TO: Mercedes-Benz and Freightliner Dealer Principals, General Managers, Sales Managers, Service Managers, Parts Managers	FROM: Thomas Brunner, Department Manager, Vehicle Compliance and Analysis Michael Scott, Vans Regulations & Certifications
RE: Recall Campaign 2017030017 MY 2015 Model 906 (Sprinter 2500,3500) Replace Fuel Tank	DATE: May 26, 2017

RECALL CAMPAIGN LAUNCH NOTIFICATION

Campaign No. :	Replace Fuel Tank
2017030017	
This is to notify you of the Recall Campaign Launch to replace the fuel tank on 2 MY15 Sprinter (906) vehicles. Please review the recall information below. The recall campaign will be visible on the www.safercar.gov website and may generate questions from customers. All affected VINs will be flagged as "OPEN" in VMI on May 26, 2017.	
Background	
Issue	Daimler AG ("DAG"), the manufacturer of Mercedes-Benz Sprinter Vans, has determined that certain Sprinter 4x4 market introduction vehicles for the US market were built with a fuel tank which does not comply with applicable safety standards. The fuel tank is not equipped with a protective plate at the front and a foam ring at the filler neck. As a result, the vehicle does not meet federal motor vehicle safety

Figure 1

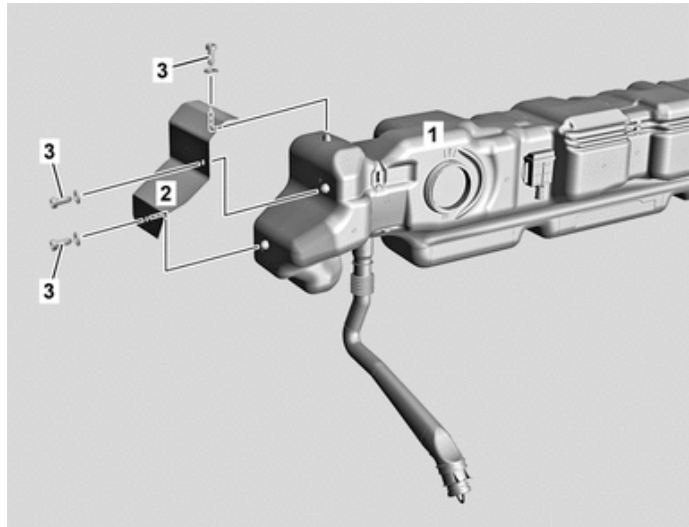
1.  Remove fuel tank (1, Figure 1) refer to WIS: AR47.10-D-4100SD.

Dispose of old fuel tank (1) properly.

2.  Mount heat shield (2, Figure 1) to new fuel tank (1) using screws (3) with washers.
3.  Install new fuel tank (1).

Figure 2 A Fuel filler neck shield

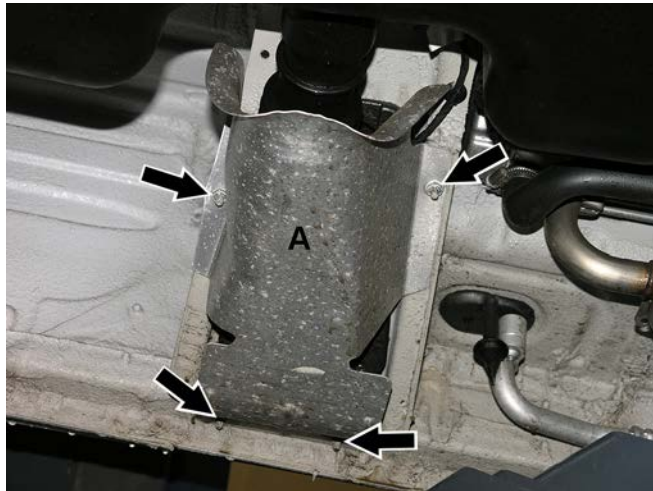
- Bolts for fuel tank tensioning straps
- Union nut and the sealing ring for the fuel delivery module.
- Protective shield nuts (arrows, Figure 2) for filler neck.
